ZONING BOARD OF APPEALS

ZBA 2013-56
 Petition of Chris Blakely
 96 Fairbanks Avenue

Plot Plan of Proposed Additions
 96 Fairbanks Avenue
 Wellesley, Massachusetts

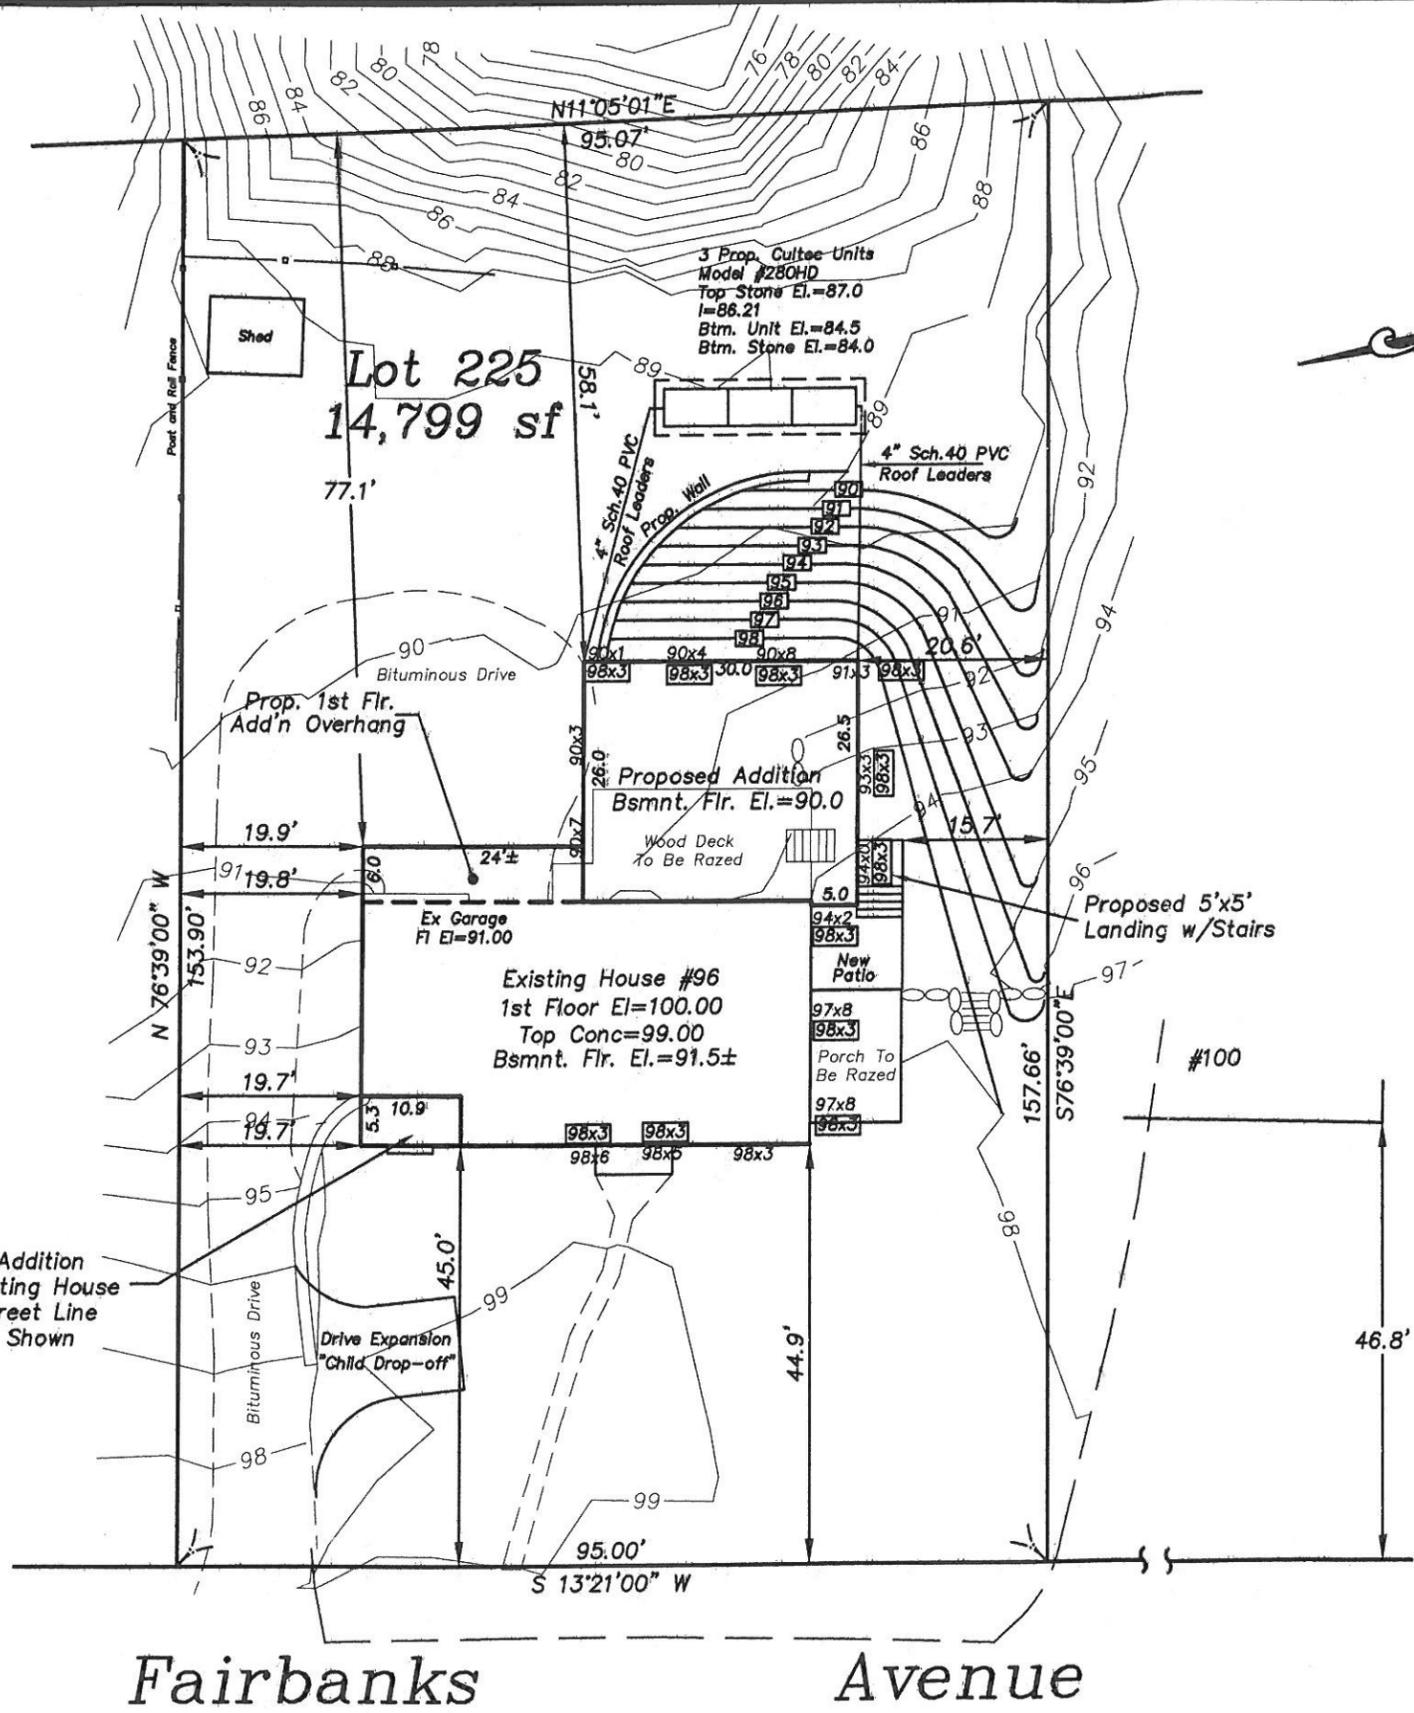
The Board said that the proposal is to roughly double the impervious area in a Water Supply Protection District. The Board said that there will be an addition, an expansion of the existing driveway and a child drop off area. The Board asked where the runoff will go to. Mr. Leaf said that runoff is at the sides of the house. Mr. Valletta said that they can design drainage for the project.

The Board said that some sort of stormwater mitigation plan would be appropriate. Mr. Leaf said that they could submit a plan that shows drywells that will handle runoff increases.

The Board said that it will need to see something that shows that the drainage will be in compliance with the Water Supply Protection District bylaw. The Board said that it will need to see something that reduces the size of the addition.

Mr. Leaf said that there is a screened porch on the right side of the house that will be taken down, which will make the right side of the house conforming. He said that they made changes to the grading to make the rear and side elevations look substantially smaller.

Mr. Leaf said that information addressing site drainage was submitted. He said that they are proposing to install an infiltration system. He said that the issue with the child drop off was also addressed.
